HYDROLOGY DEVELOPMENT SECTION DEVELOPMENT REVIEW BOARD MEMO

DRB PROJECT NO: 1003916

Re: Santa Monica Place Tracts 1-4, Conceptual Drainage Report
Engineer's Stamp dated 12-2-2011 (D18/D054)

**Re: Broadstone Santa Monica Place
Grading and Drainage Plan
Engineer's Stamp dated 4-10-2012 (D18/D054)**

OVERFLOW WEIR AT CONCRETE STILLING BASIN @ NW CORNER

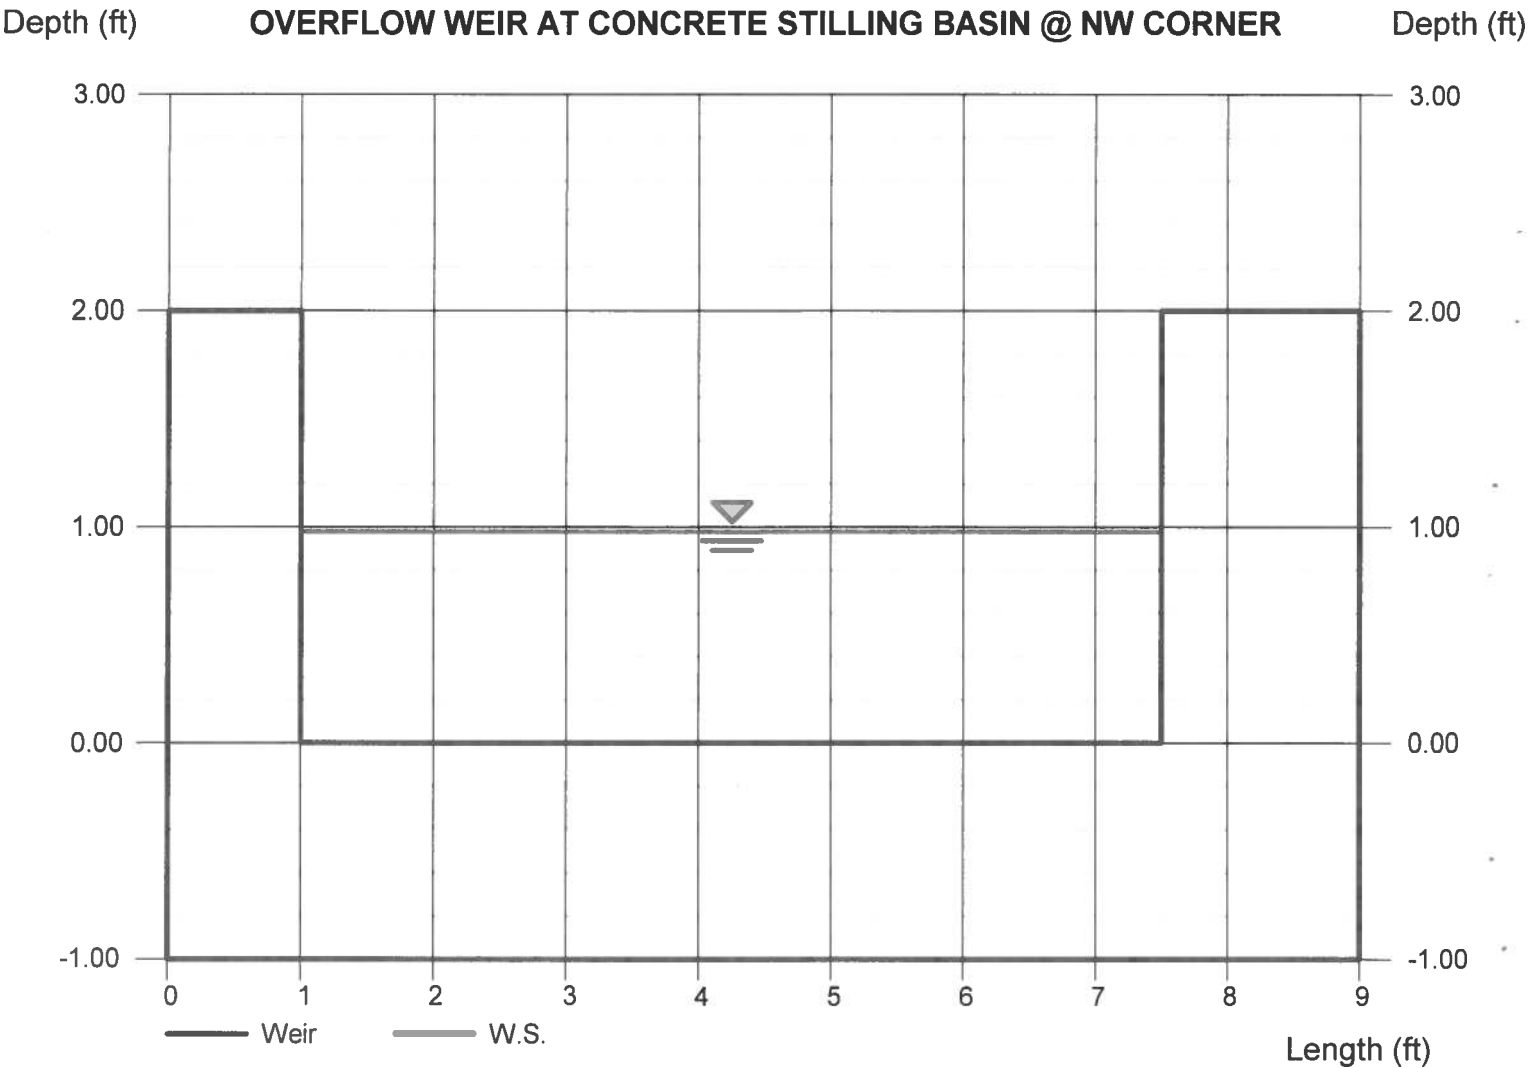
- Pond calculations are needed for the small pond just north of the entrance/exit on San Pedro. What is the WSE?
- How are the proposed contours tying in with the contours to the north of this site at the NW corner?
- Provide the direction of roof flows for the units in the NW corner. These flows should not drain over the sidewalk.
- Are all landscape areas being depressed as well as the areas with sidewalk culverts? Can the small islands in the parking lots contain a 1' cut in the curb to accept flows? This would assist in lowering the flows entering San Pedro for the first 6 hours and would also help with the new EPA regulations and the MS 4 permit coming in the near future.

1. The intent of the storm drain outfall structure is to dissipate the velocity of the storm drain discharge and overflow it to the south paved drive over a 6.5-foot wide weir. Flow remaining in the lower 6 inches will pass to the north via the proposed 4-inch drainline. The peak flow in the 4-inch pipe is 0.5 cfs and the remaining flows of 21.0 cfs discharges via the weir. See Supplemental Calculations for weir overflow and 4-inch orifice calculations. Based on these calculations, the water surface elevation will be 63.0—one foot above the flowline elevation. The curb adjacent to the weir will be 12 inches high with transitions to the top of wall elevation of 64.5.

- **WEIR CALCULATIONS FOR STILLING BASIN
NORTH OF SAN PEDRO ENTRANCE**
- **ORIFICE CALCULATIONS FOR 4" PIPE FROM
STILLING BASIN TO SIDEWALK CULVERT
NORTH OF SAN PEDRO ENTRANCE**

Crest = Sharp
Bottom Length (ft) = 6.50
Total Depth (ft) = 2.00

Weir Coeff. Cw = 3.33
Compute by: Known Q
Known Q (cfs) = 21.00

Depth (ft) = 0.98
Q (cfs) = 21.00
Area (sqft) = 6.37
Velocity (ft/s) = 3.30
Top Width (ft) = 6.50

BROADSTONE SANTA MONICA
EXHIBIT

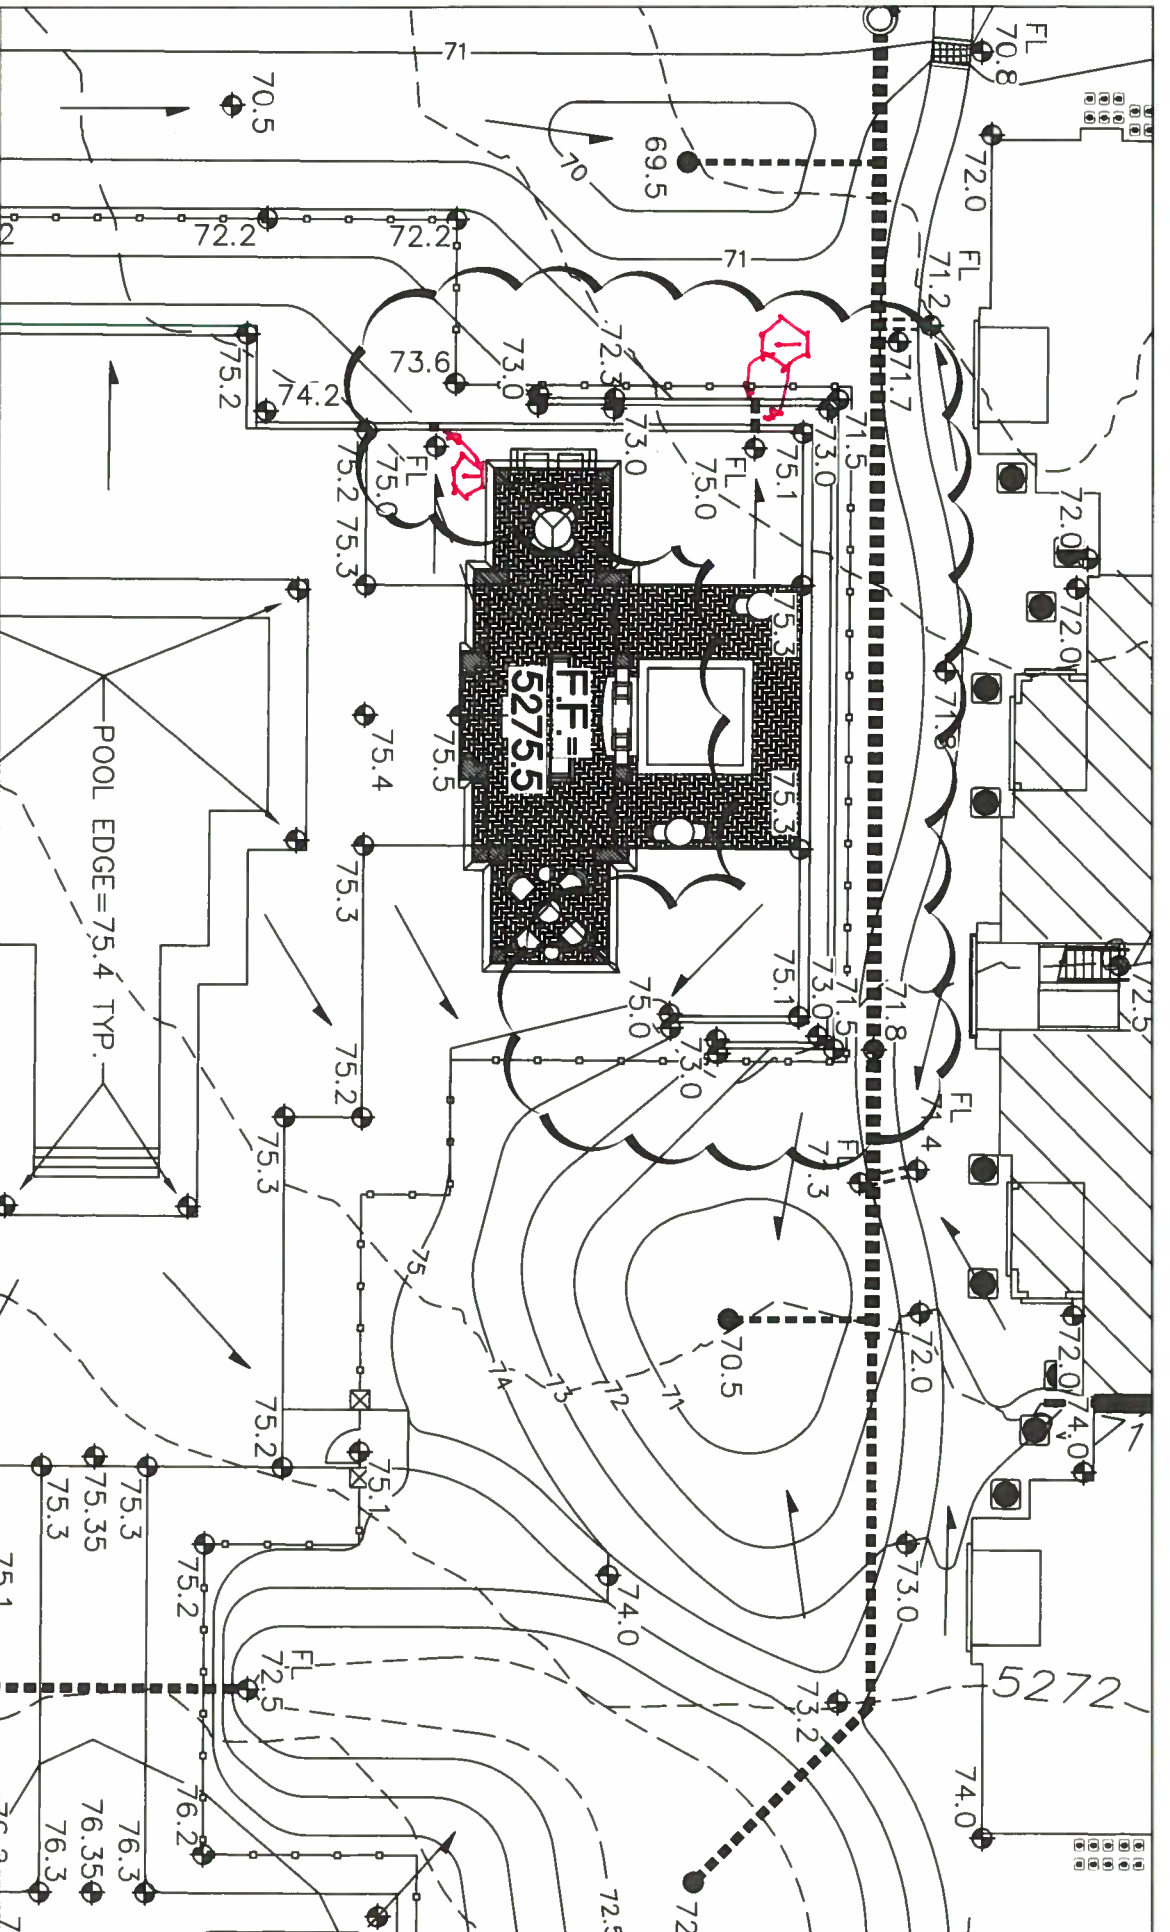
①: PROVIDE 4" DIA BRASS PIPE
THROUGH WALLS. INV. OF
PIPE TO BE 4" BELOW
FINISH GRADE.
